CITY OF HAYWARD AGENDA REPORT

Planning Commission

Meeting Date 12/11/03

SUBJECT: Use Permit PL-2003-0075 - Pick-Your-Part Auto Wrecking
(Applicant/(Owner): Request to Continue Operation of an Automobile
Dismantling/Recycling Business - The Project is Located at 2885 West
Winton Avenue in the Industrial (I) District

Figure 3: Site Plan

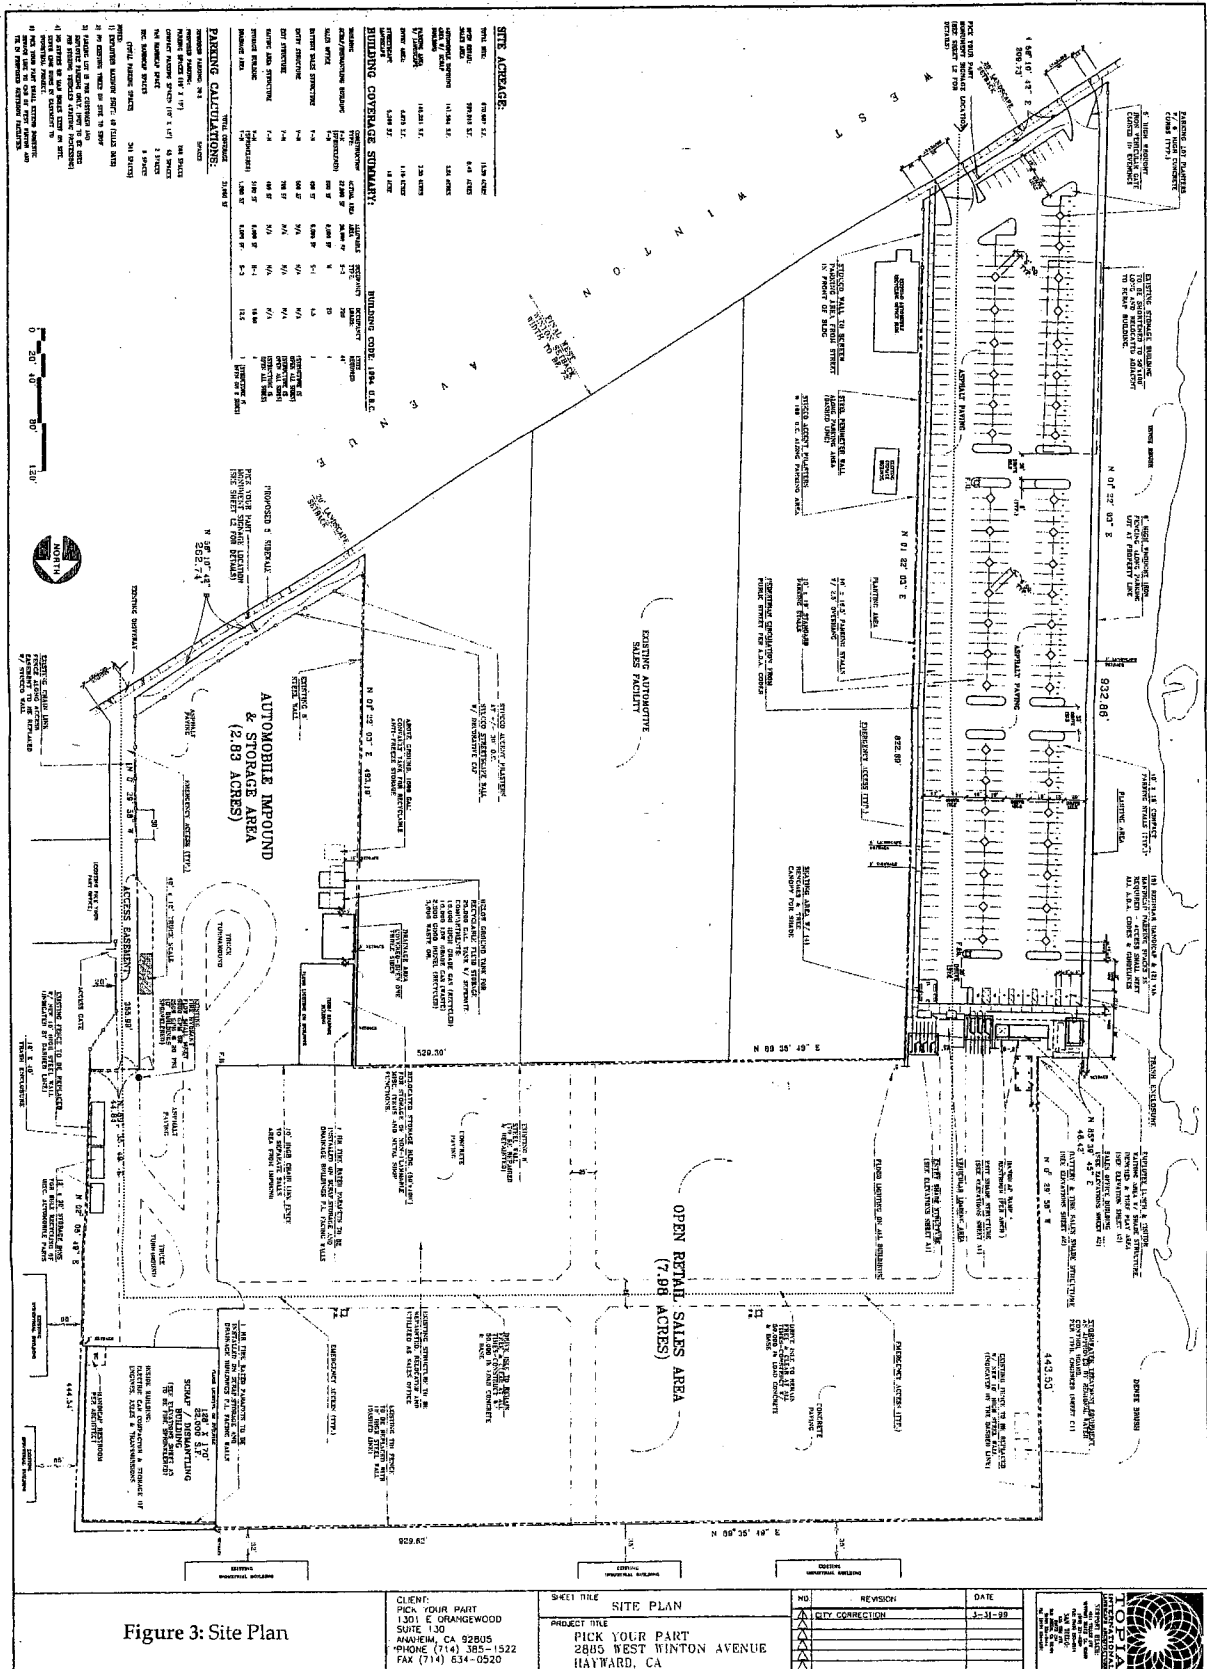
Pick-Your-Part has submitted revised site plans to the City of Hayward as part of their Use Permit application (Figure 3). Improvements to the site are proposed and include:
